**NOTE:**The following are changes Texas Star made to the DX1600V Final Chassis from Feb. 2006 to Mar. 2007.

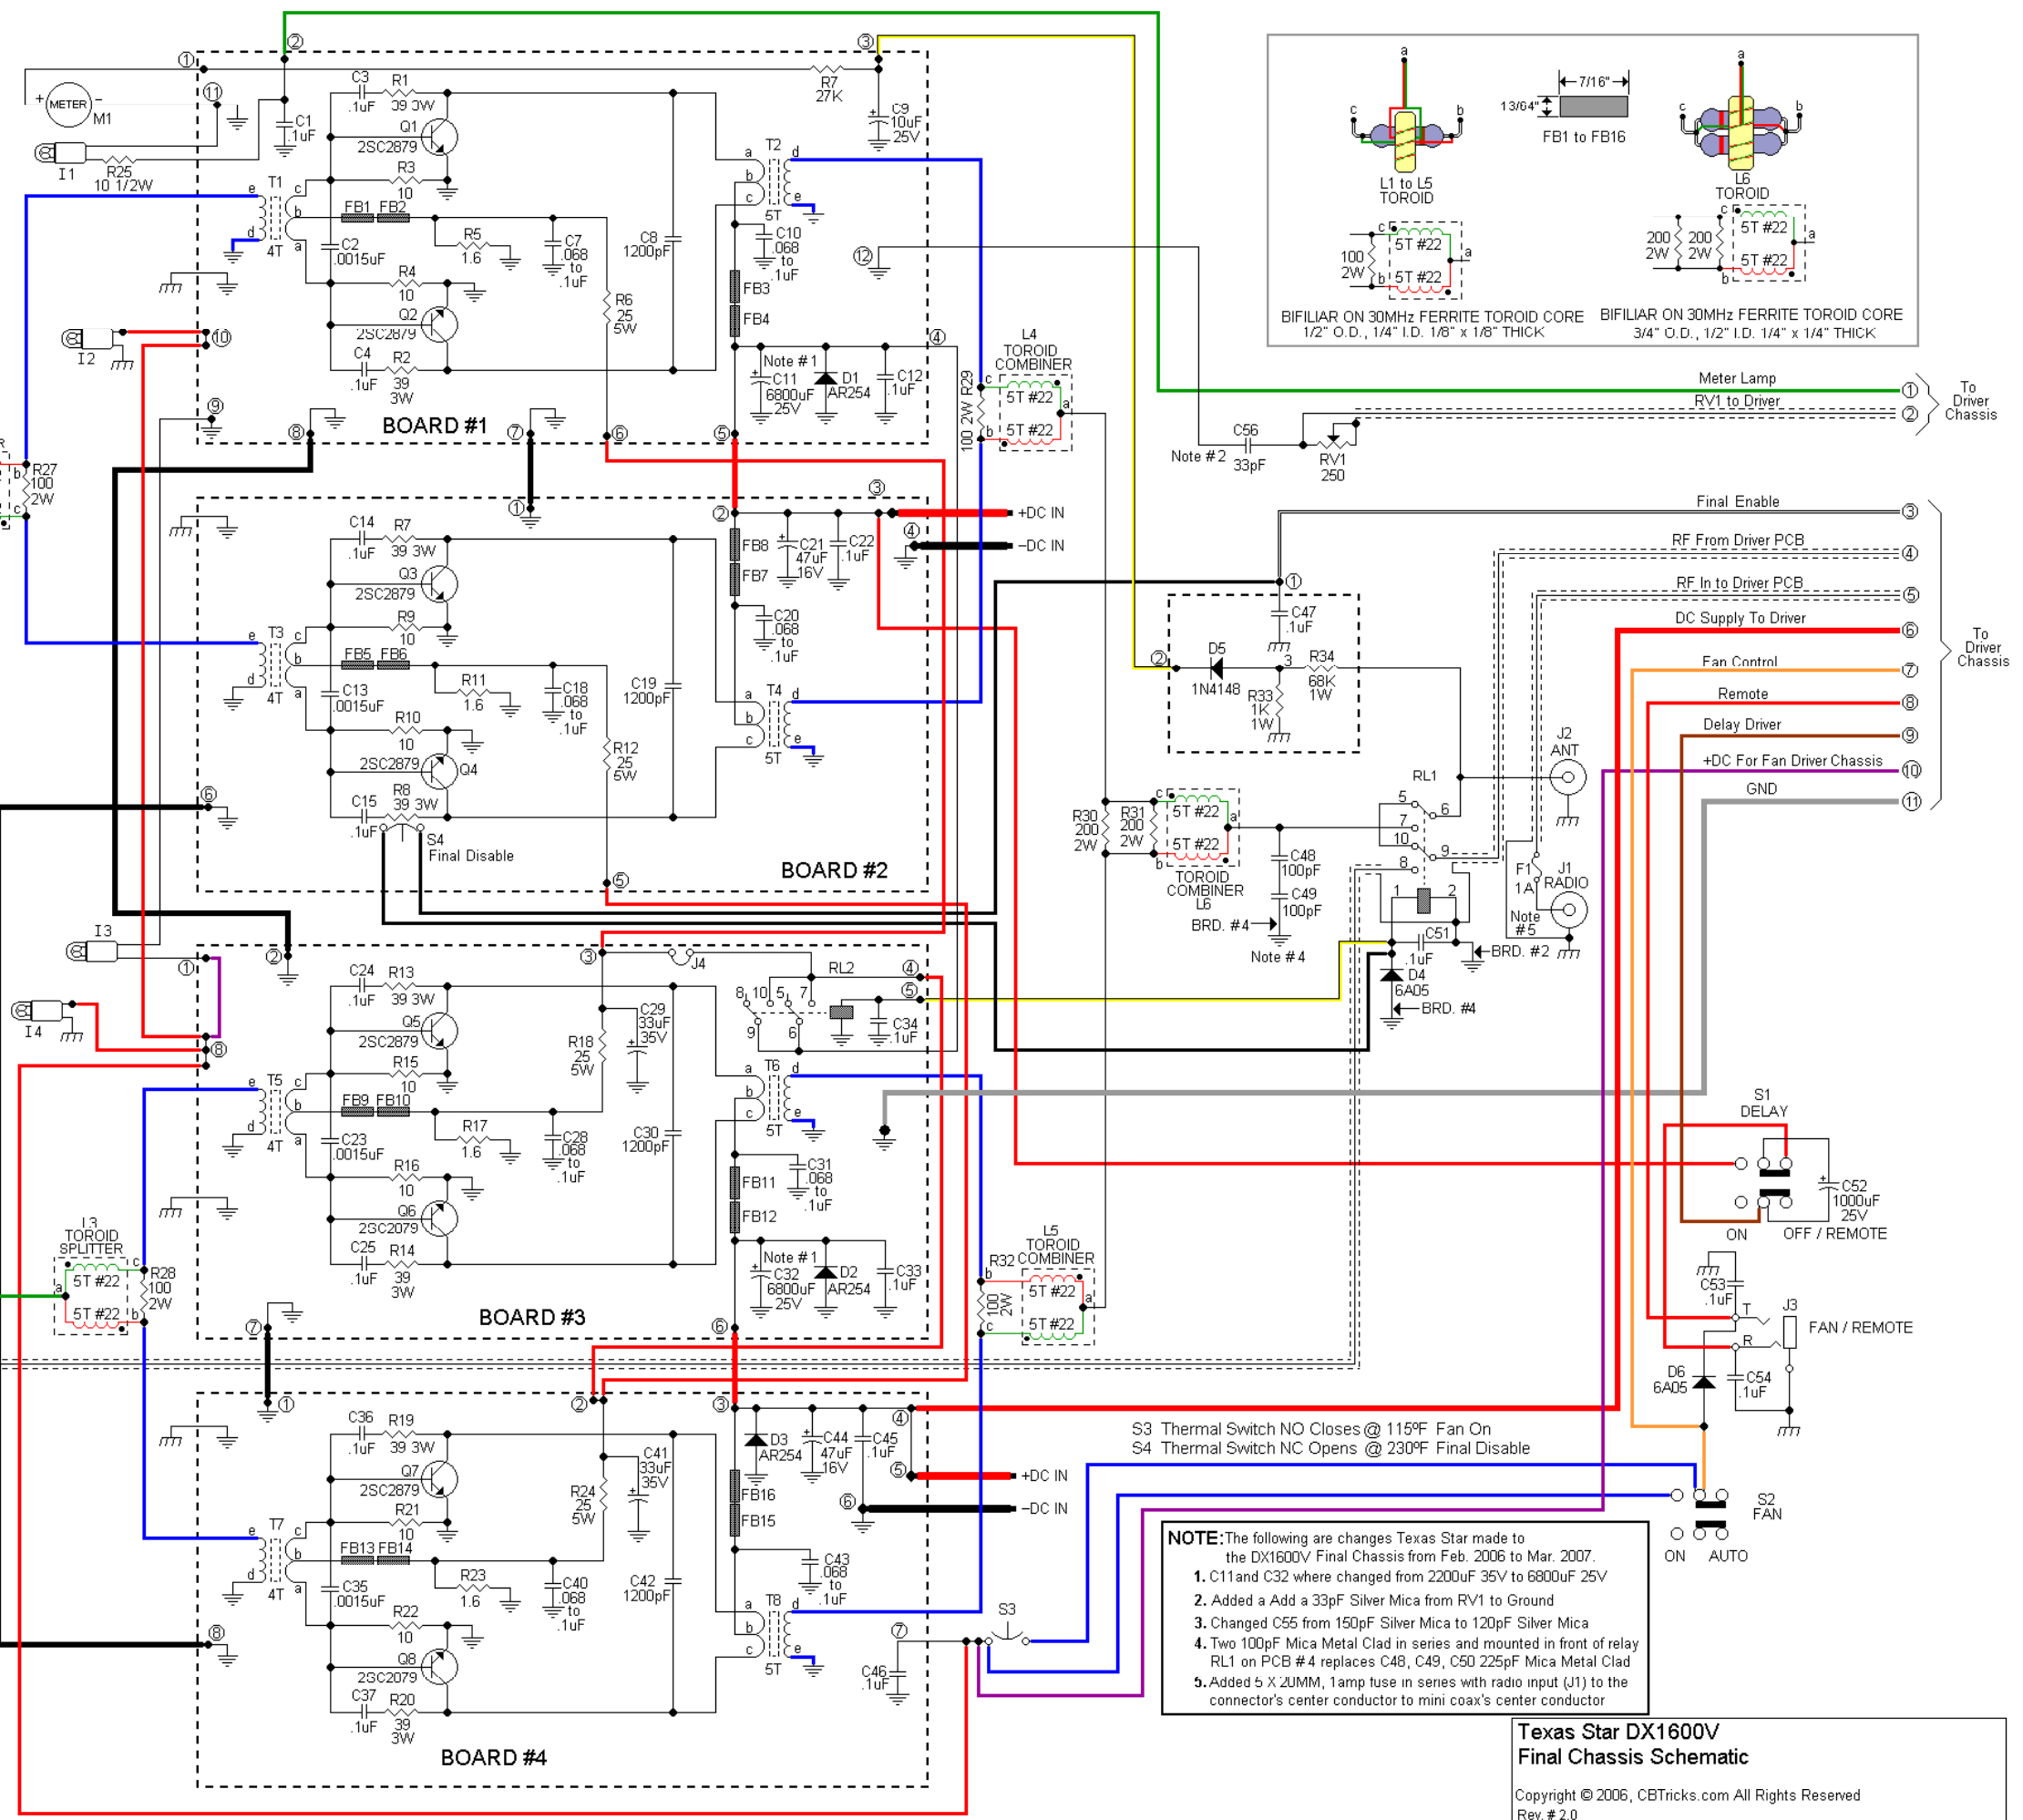
Aromat  
12T-12V-9-H1  
Coil 12Vdc 185  
1A @ 125vac  
2A @ 28vdc  
Relay RL2 was  
changed Mid 2007 to  
Fujitsu LZ-12VM-K,  
SPST-NO, 10 amp.

1. C11 and C32 where changed from 2200uF 35V to 6800uF 25V
2. Added a Add a 33pF Silver Mica from RV1 to Ground
3. Changed C55 from 150pF Silver Mica to 120pF Silver Mica
4. Two 100pF Mica Metal Clad in series and mounted in front of relay RL1 on PCB #4 replaces C48, C49, C50 225pF Mica Metal Clad
5. Added 5 x 2UMM, 1amp fuse in series with radio input (J1) to the connector's center conductor to mini coax's center conductor
